COLBY CIRCLE STORM DRAIN IMPROVEMENTS PROJECT

C.I.P. 2026-4

ADDENDUM No. 2

September 24, 2026

GRIND AND OVERLAY LIMITS

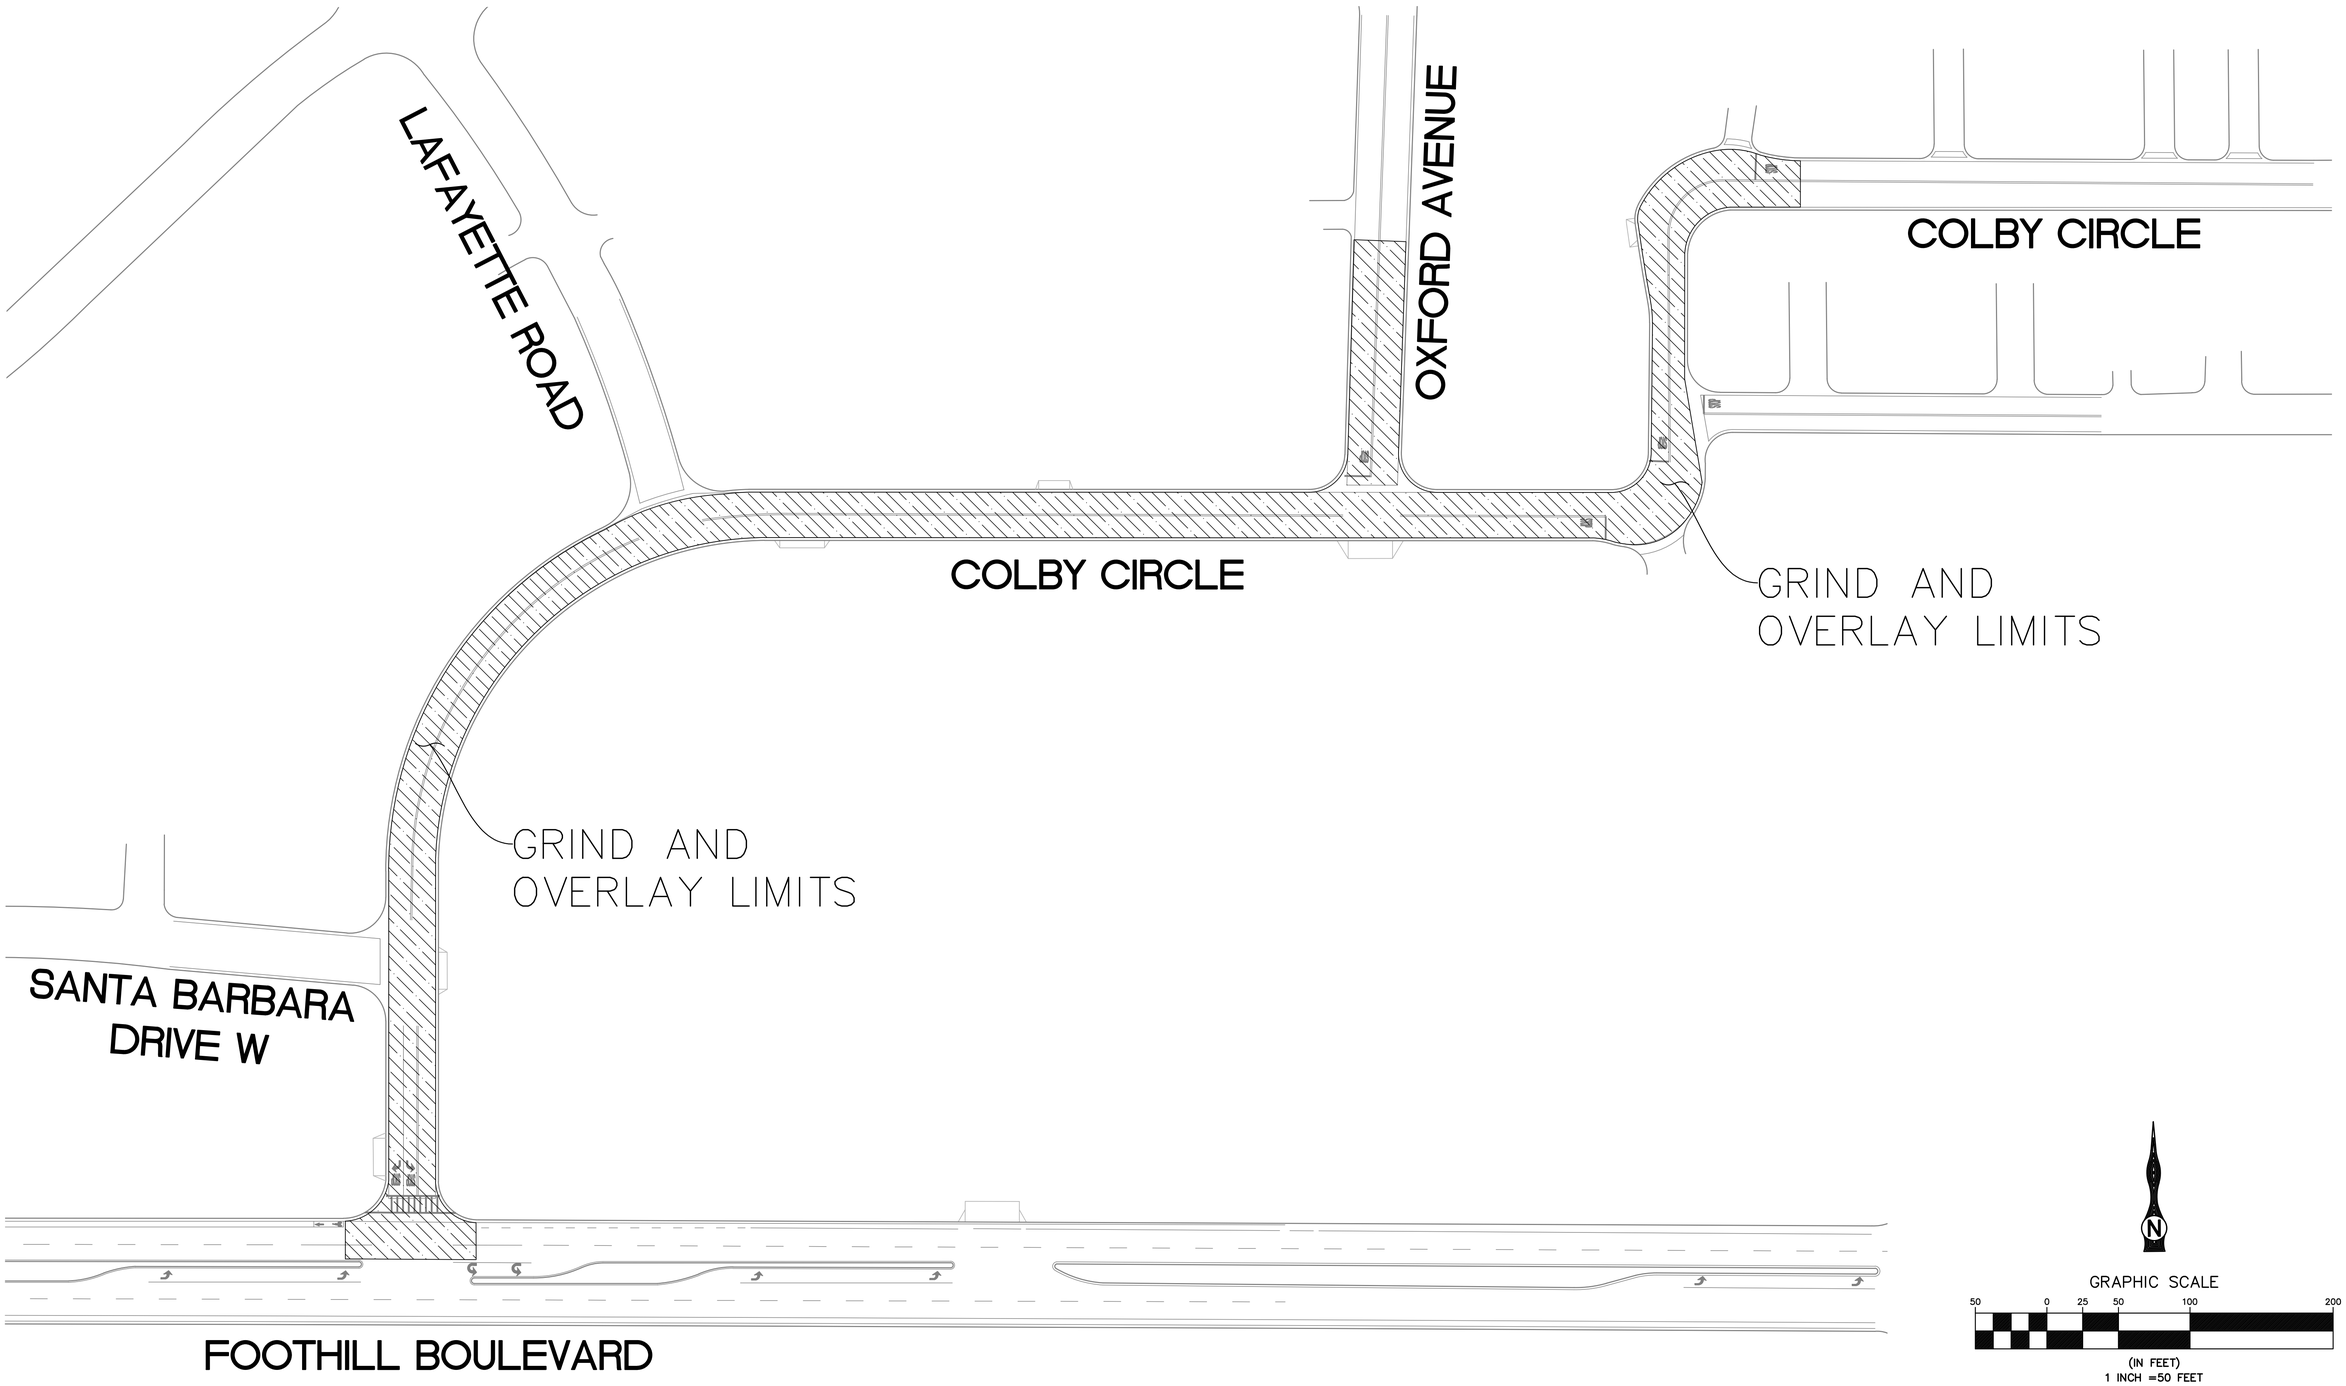
2. **Page 95, Section 00750 – 11.) 2" Asphalt Concrete Pavement Grind (Cold-Mill) and Overlay (Bid Item #29)**

Appending this section, providing a diagram to reflect the grind and paving boundaries for bid item #29.
